Product Change Notification

MultiConnect[®] rCell 100 Series Cellular Routers

Date: January 25, 2022

PCN 10272021-004 (mPower - MTR)

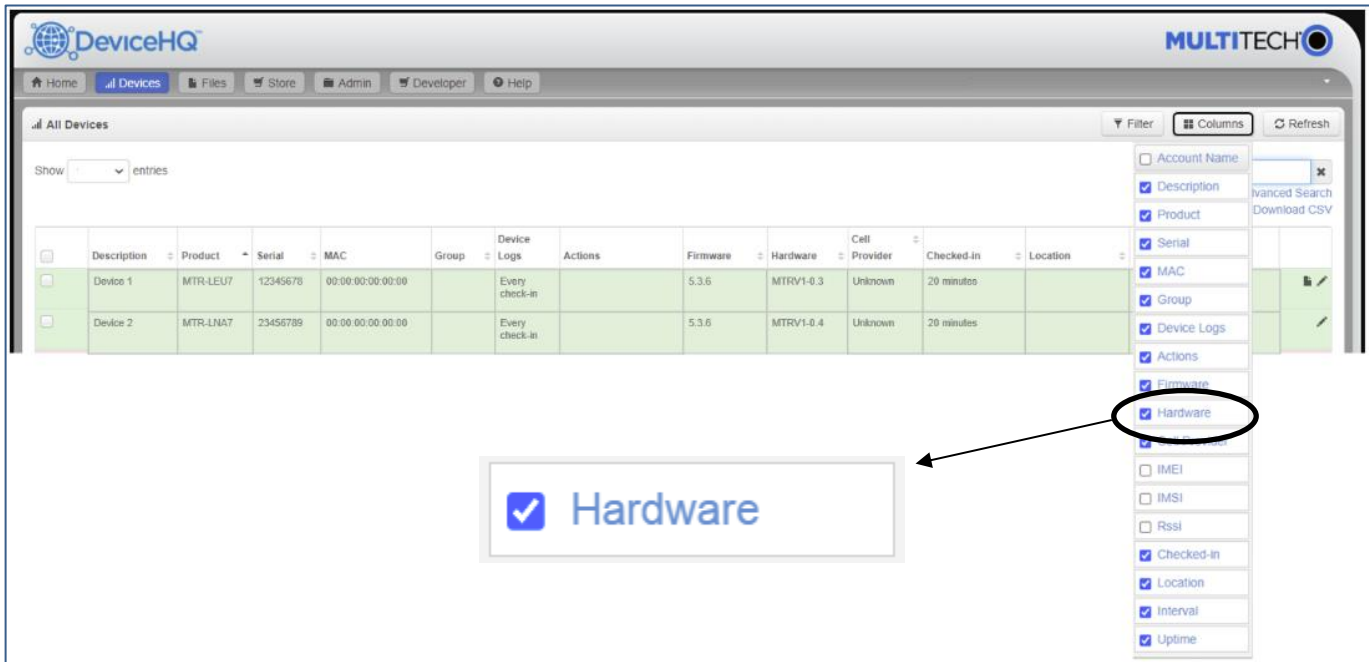
- MTR device with original components -- “MTRV1-0.3”
- MTR with substitute components -- “MTRV1-0.4”

1. **Model Numbers:** New model numbers are not required. Existing model numbers will continue to be used regardless of components.

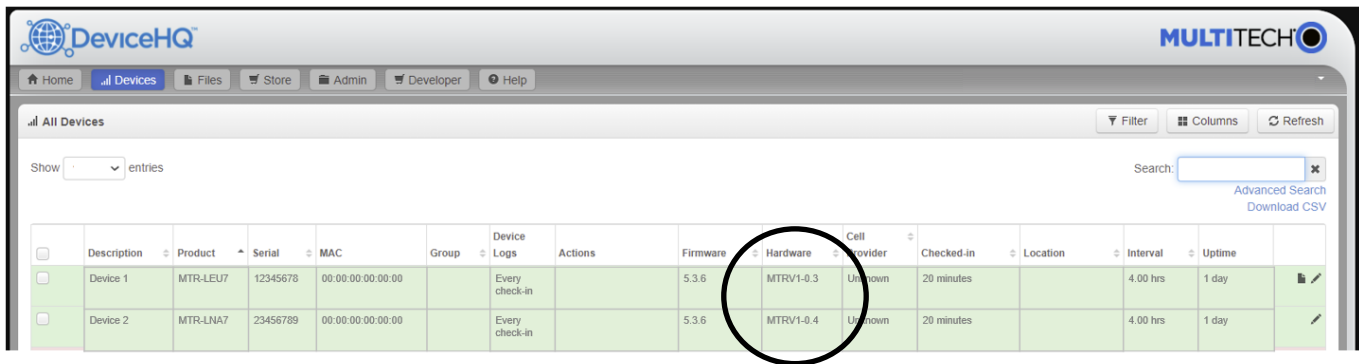
- **MTRV1-0.3** - MTR device with original components
- **MTRV1-0.4** - MTR with substitute components

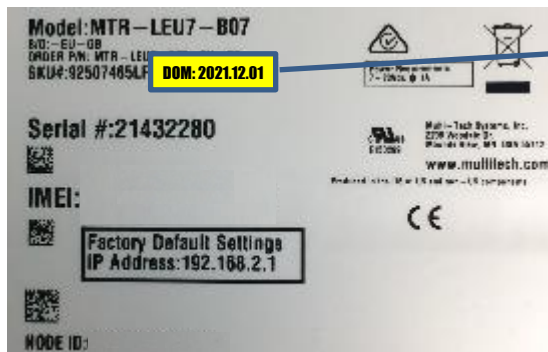
1. Downgrade Protection:
 - a. mPower 5.3.6 includes a means of identifying the MTR LTE Category 4 device (original components or substitute components) and limit the version of mPower that customers can use
 - i. Original Components: Downgrade to legacy mPower MTR versions is allowed
 - ii. Substitute Components: Downgrade is not available.
 - Devices with substitute components can only be used with mPower MTR 5.3.6 and later
 - Future mPower versions will not downgrade to versions of mPower prior to mPower MTR 5.3.6
 - b. The downgrade protection feature prevents customers from downgrading the MTR device to an unsupported version of mPower software.
 - c. DeviceHQ will include a similar feature that prevents customers from downgrading the MTR device to an unsupported version of mPower software.
 - d. Error Messages:

If a user attempts to downgrade the MTR with substitute components to an incompatible firmware version, an error message will be displayed:

- Downgrade using API Command: "Firmware check failed. Invalid firmware version for [MTRV1-0.4] hardware."
 - Downgrade using DeviceHQ: "Software check failed. Invalid firmware version for [MTRV1-0.4] hardware."
 - e. [GP-1386]
